CZECH SPORT AIRCRAFT	<h1>SERVICE BULLETIN</h1>	Czech Sport Aircraft a.s. Na Záhonech 212 686 04 Kunovice Czech Republic info@czechsportaircraft.com	
		No.: SB-CR-071	Rev.: -
		Date: 2019-08-19	Date: -
Page: 1 of 7

MODEL AFFECTED:	PS-28 Cruiser / SportCruiser / PiperSport (operating under EASA rules)
SUBJECT:	Inspection and eventual adjustment of sufficient distance between exhaust and cooling tubes
AIRCRAFT AFFECTED:	PS-28 Cruiser / SportCruiser / PiperSport aircraft with dual circuit thermostat valve Hektic F 1104 installed
COMPLIANCE:	Apply this Service Bulletin as soon as possible, not later than before completing three flight hours as of the day of this Service Bulletin issue. Apply this service Bulletin every 100 FH or at any time when any works on exhaust or cooling tubes are performed.

Figure 1: Distance between exhaust and coolant tube

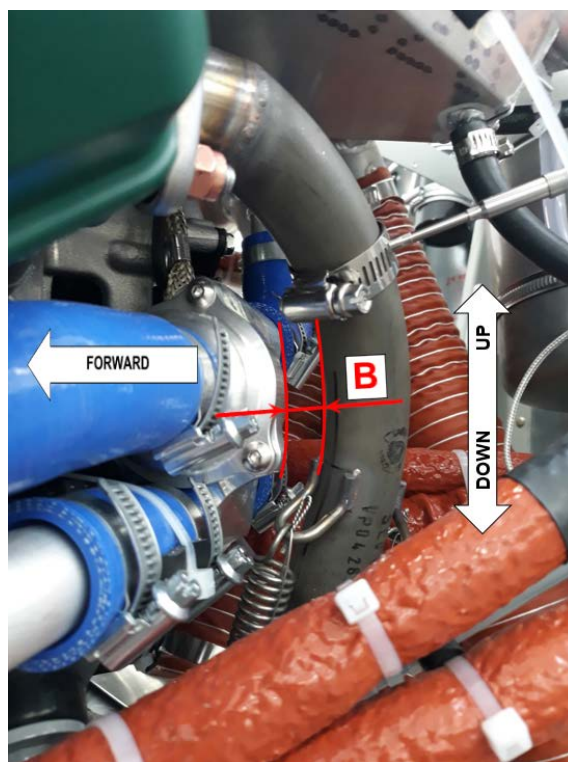
6. Remove the engine lower cowling (see the CR-MM-1-0-00 or SC-AMM-1-0-00, the latest revision).
7. Inspect tubes of cooling system on sufficient distance from exhaust tubes or other components (engine body, engine mounting, etc.) according to Figures 1 - 7. Ensure that at least the minimum distance provided in Table 1 below is kept.

Figure No.	Dimension	Recommended minimum distance from hot parts and other components (mm)
Figure 1: Distance between exhaust and coolant tube	A	8
Figure 2: Distance between exhaust and thermostat valve	B	8
Figure 3: Distance between cooling tube and engine mount – left side – bottom view (left side)	C	5
Figure 4: Distance between cooling tube and engine mount – right side – bottom view (right side)	D	5
Figure 5: Distance between cooling tube and alternator sensor – view from above	E	5
Figure 6: Distance between cooling tube and Spark plug – view from the right	F	2
Figure 7: Distance between cooling tube and fixing stripe free ends	G	10

8. If needed, release fixing stripes and clips and adjust positioning of cooling tubes in hose fittings accordingly. The recommended minimum distances are shown in Table 1.

- In case the insufficient distance is between cooling tube and exhaust system, protect relevant cooling tube from exhaust system by applying proper thermo-insulating foil, or
- In case the insufficient distance is between cooling tube and other than exhaust parts of engine compartment (engine mount, spark plugs, etc.), protect the relevant tube from undesirable contact by a applying sufficient dampening insert (e.g. Silicone tube ID25, MVQ-blue, QI 512K2204).

Figure 7: Distance between cooling tube and fixing stripe free ends

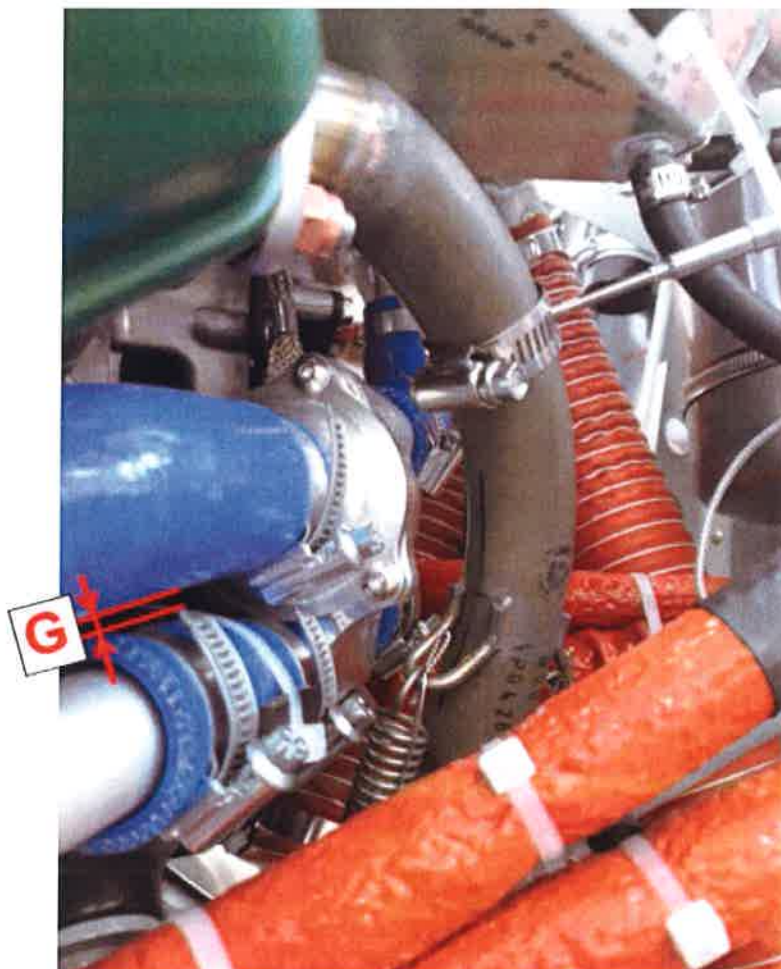
Note to figure 7: Stripe end should be bent in order to prevent damage of the hose in case of accidental contact.
